Access Compliance Report Public Rights-of-Way (Curb Ramps)

Main Street: ARROYO_AVE		Cross Street: RISA_PL		Location:	E
ADA ID: RPRK211012122748	Ramp Type: Type 4 - Parallel	Initial Pass/Fail: Fail	Overall Compliance: No	Severity Score:	4

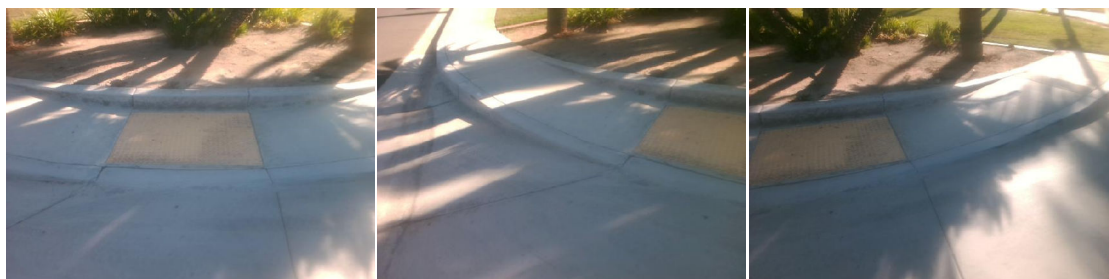
Compliance	Description	Data	Compliance	Description	Data
N/A	Ramp Length LT (in)	90	N/A	Ramp Length RT (in)	96
No	Ramp Width LT (in)	42	No	Ramp Width RT (in)	42
Yes	Ramp Run Slope LT (%)	8	Yes	Ramp Run Slope RT (%)	4.8
Yes	Ramp Cross Slope LT (%)	0.9	Yes	Ramp Cross Slope RT (%)	1.1
N/A	Landing Present	N/A	N/A	DWS Provided	N/A
N/A	Landing Length (in)	N/A	N/A	DWS Contrast	N/A
N/A	Landing Width (in)	N/A	N/A	DWS Length (in)	N/A
N/A	Landing Run Slope (%)	N/A	N/A	DWS Full Width	N/A
N/A	Landing Cross Slope (%)	N/A		DWS Offset Type	N/A
N/A	Landing Movement Obstructed?	N/A	N/A	DWS Offset Left (in)	N/A
	Landing Movement Type	N/A	N/A	DWS Offset Right (in)	N/A
N/A	Landing Shared	N/A			
N/A	Clear Space	Yes			
N/A	Clear Space To Crosswalk (in)	N/A			
N/A	Marked Crosswalk 1	No	N/A	Marked Crosswalk 2	No
	Crossing 1 Direction	NW		Crossing 2 Direction	SW
	Marked Crosswalk 1 Width (in)	N/A		Marked Crosswalk 2 Width (in)	N/A
N/A	Ramp Inside Crosswalk 1	N/A	N/A	Ramp Inside Crosswalk 2	N/A

Crossing 1 Slope (%)	8.5		Crossing 2 Slope (%)	4
	Crossing 1 Cross Slope (%)	2.4		Crossing 2 Cross Slope (%)	1.5
N/A	Gutter Ponding	N/A	N/A	Curb Slope	10.2
Yes	Gutter Lip Height (in)	0		Road Run Slope (%)	0.6
N/A	Gutter Run Slope (%)	N/A		Road Cross Slope (%)	4.8
N/A	Gutter Cross Slope (%)	N/A	Yes	Perpendicular Joint Present	Yes
Yes	Overall Surface Condition	Acceptable			
	Cross Gutter Present?	Yes		Spandrel Present?	Yes
	Replace Cross Gutter?	No		Replace Spandrel?	No

Remove & Replace Curb Ramp With Two New Directional Ramps or Equivalent.
